Douglas Grant
PO box 1027
110 w Homestead Dr.
Basalt co. 81621
970-927-3201 H
970-274-0543 c
douggrant@sopris.net
March 12, 2020

Scott Contracting has submitted an application for a 112 permit in the name of Rifle Gravel Pit #1 to the Div. of Reclamation Mining and Safety- Mined Land Reclamation Board. (M2020-008) ACY/THM

I am writing to express my concerns about several issues directly affecting my property and mining operation as well as some ambiguities in the application.

Figure 3. Exhibit C - Affected Lands and Roads

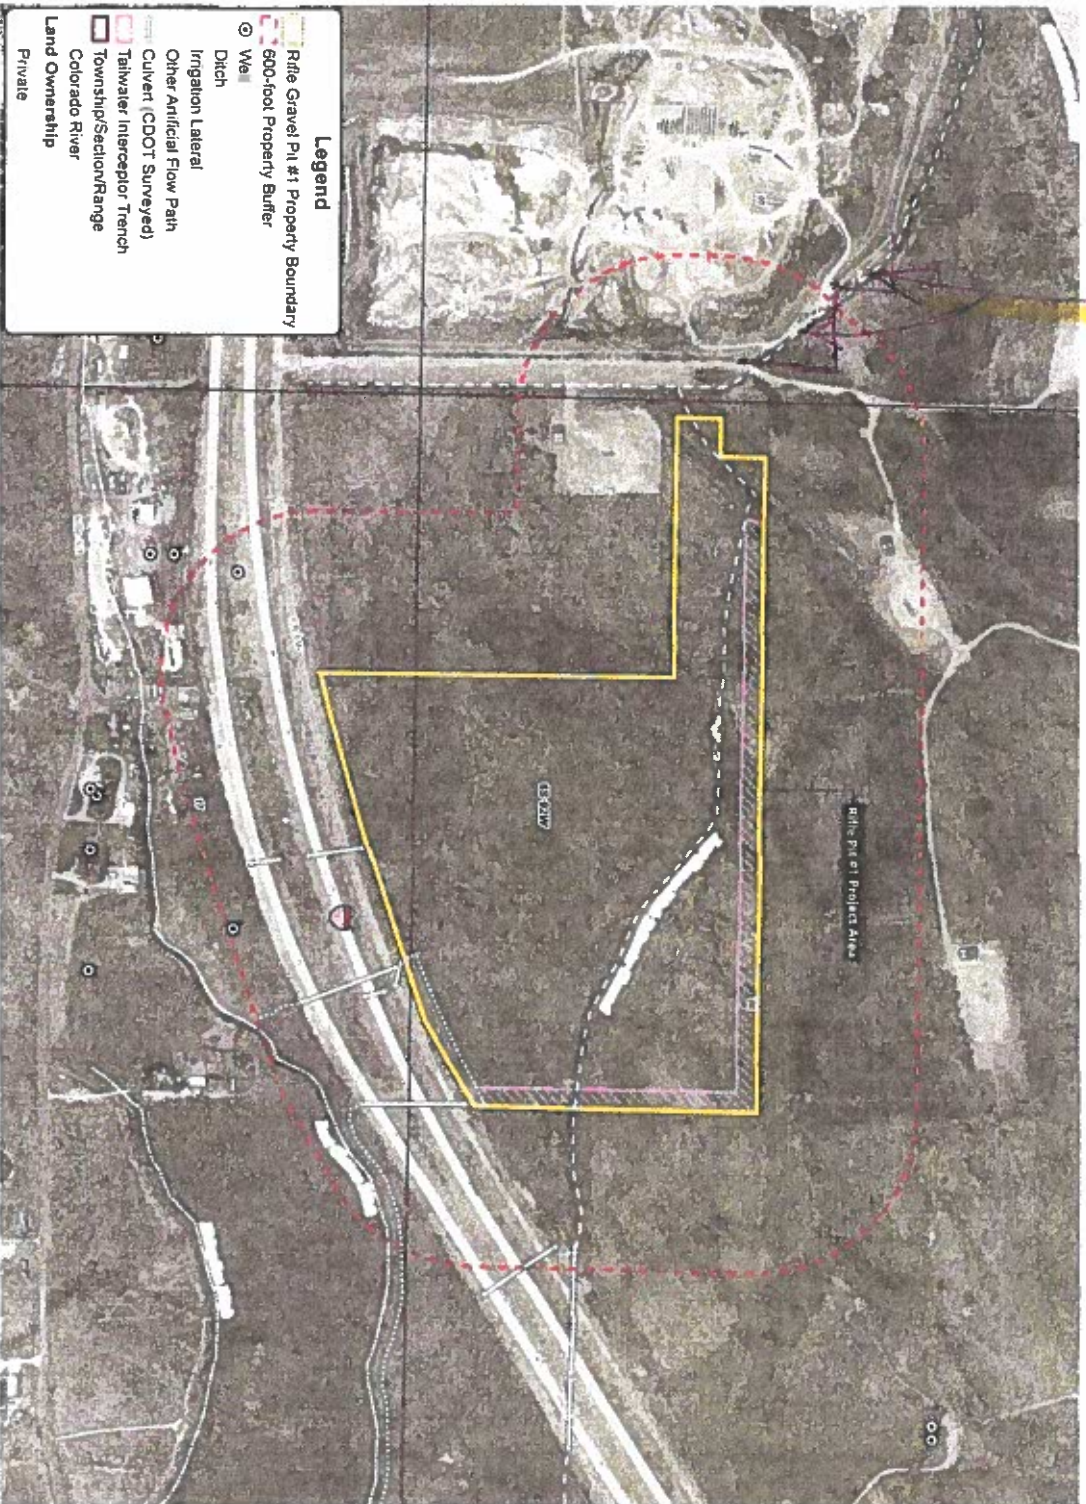
First and foremost the application states that the dewatering well will discharge into an onsite existing tailwater ditch that reaches the Colorado River. The water pumped to this tailwater ditch goes across our property in two places and parallels the north boundary of our property to eventually get to the Colorado River. This ditch has a flow that rises and falls with the seasons very little in winter months and an increase in the irrigation season that is irregular tailwater flow. The applicant has no permission to use the ditch that crosses our property for dewatering purposes. Pumping water to dewater a gravel pit is year round and could possibly be perpetual if an evaporative loss replacement contract cannot be obtained at the end of mining. The pumping of ground water to the ditch that was dug years ago to remove surface water from running across our property originating east of us is not an appropriate use nor do I believe a legal use and it is not acceptable in any way. Pumping more water to the ditch increases the flow raises the water level in the ditch and will increase the amount of infiltration into the gravel pit resulting in more cost to dewater our pit and may affect our reclamation of the pit walls resulting in injury to our property and gravel pit operation. Nowhere in the application is there an estimate or projection of the

Grant Bros. property line (red) approx.

Drain Ditch on over property and along East & North boundaries.

Figure 10. Exhibit F Reclamation Plan Map

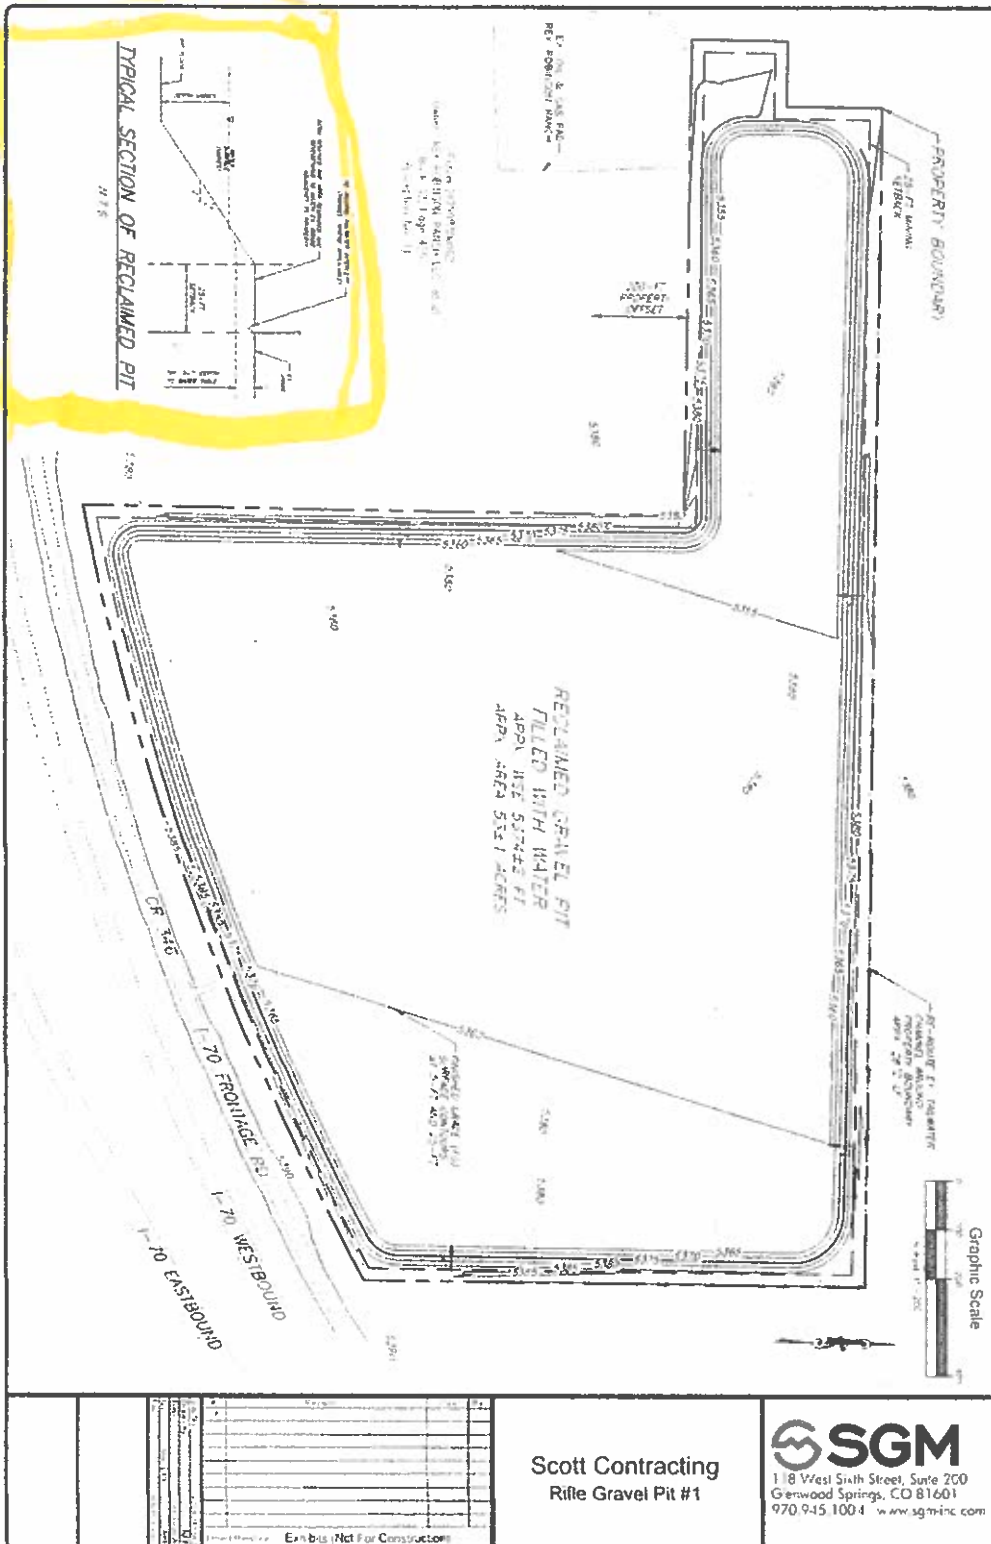
All through the application and letters to the county and soil conservation service it states the end use is pasture land and irrigated pastureland. Then goes on to show a drawing figure 10 a reclaimed gravel pit filled with water (53 acre pond). Also calculation tables for water consumption by evaporation on the pond surface. What is the end use going to be?

Figure 10 shows the pond and 25 foot buffer and in the lower right corner the tailwater ditch. 25 foot buffer is not adequate. Gravel pits nearby have 35 foot buffers on the side's 100 foot buffers from the river and 200 foot in front along the frontage road. 200 foot buffers along the frontage allows for parking, buildings, picnic tables if a pond is the final use and access to the property without parking or crossing others property no matter the end use. 25 foot buffer is not enough to prevent back cutting of the pit wall from reaching the adjacent property if the pit is mined vertical right to the 25 foot buffer. When large underground streams of water come out of vertical pit walls they can slough the wall to a slope that could reach the adjacent property. Even when dirt is used to slope the vertical wall for reclaiming water can wash the dirt into the pit and still allow the pit wall to back cut into the buffer and potentially to the adjacent property. The tailwater ditch within the 25 foot buffer can saturate the pit wall enough to cause a slouching (caving) situation that could reach the adjacent property as well as be a serious safety problem if someone or equipment is in the bottom of the pit while mining and the pit wall caves- in. The 25 foot buffer has a soil pile with a 24 foot footprint that loads the vertical pit wall on top. This loading adds even more to the chances the saturated pit wall will fail resulting in a cave-in.

Is there surface land for an oil and gas well pad mentioned in the exceptions? Can land for a well pad be provided for with a 53 acre pond as depicted in figure 10?

This shows 1 foot ditch in the 25 foot buffer where is parking and access, oil pad area, ditch cleaning access area?

This shows a 24' base for soil pile in the 25 foot buffer just above and on the edge of the vertical pit wall as high as 20 feet plus.
